Your Ref SSD-79791208

Submission to Request for Advice on 2 Fitzwilliam Street Parramatta- State Significant Development Application, Amendment to Concept Application and concurrent rezoning (Ref: SSD-79791208)

Attachment A

Figure 2 Changes to Through-Site Link

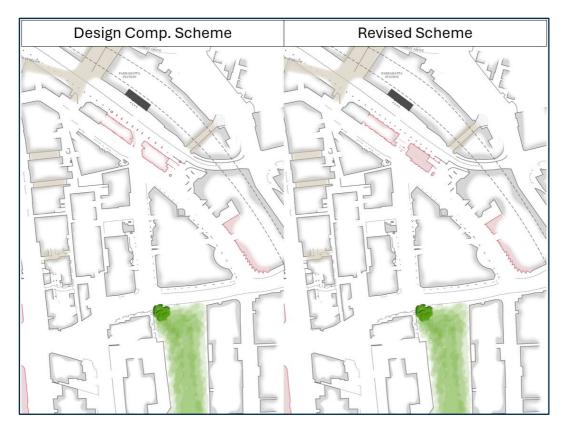
The through site link between Fitzwilliam and Argyle Streets has been changed in alignment and form from the original Design Competition scheme and **Council Officers object to the current design and request that the pedestrian link be redesigned to reflect the original competition design.** The angled 9 metres wide link was one of the key design features that was supported by

The current proposal locates the link in a different position, widens the space and organises the access through the link across the line of movement rather than with the line of movement. The space, columns, levels and upper-level projections within the link between Fitzwilliam Street and Argyle Street result in a confused illegible space. The various levels, palm trees and skylights indicated, further confuse the space.

- While the link is currently wider, it is much more convoluted and the movement much longer and restricted for wheelchair users.
- It is more cluttered visually, with a lot of columns and trees breaking the sight lines.

- The water feature is not supported and will likely form a trip and fall hazard for people rushing about.
- The two changes in the soffit height of the colonnade on Argyle Street and on Fitzwilliam Street at the entrance to the link confuse the legibility of the entrance to the link and the spatial characteristics of the colonnade. There should only be one change in soffit height over the entrance to the link on both street frontages.

- On Levels 00,01,02 the western wall of the eastern tower and the eastern wall of the western tower have irregular profiles that do not clearly define the space that makes the connection.

- The entrance to the link is recessed under the Level 02 and the upper levels of the podium.
 This creates an ill-defined relationship between the space, the building and the ground plane of building meeting the ground

- The link connects the station to Jubilee Park. This sight line along Wentworth Street needs to be considered as part of this larger scale relationship between land and water given that the Clay Cliff Creek runs though Jubilee Park (see below figure).

- There is no direct stair access from Argyle Street to Fitzwilliam St. There is an irregular arrangement of columns through the link, and one located directly in front of the stairs from Argyle Street. The through site link needs to be designed:

- as a simple clear legible space that provides direct views from the east side of Wentworth Street from Jubilee Park through to Argyle Street. See sketch attached for the alignment.

- to provide both wheelchair accessibility and a stair that provides the shortest access between the two streets
 - to ensure that the columns relate to the built edges so that both the built form edges and the columns define the space rather than the columns sitting randomly in the space.

- The under-croft of the link is to be one level from Fitzwilliam Street to Argyle Street.
- The applicant is to provide accurate plans and sections though the link from Fitzwilliam Street to Parramatta rail station.
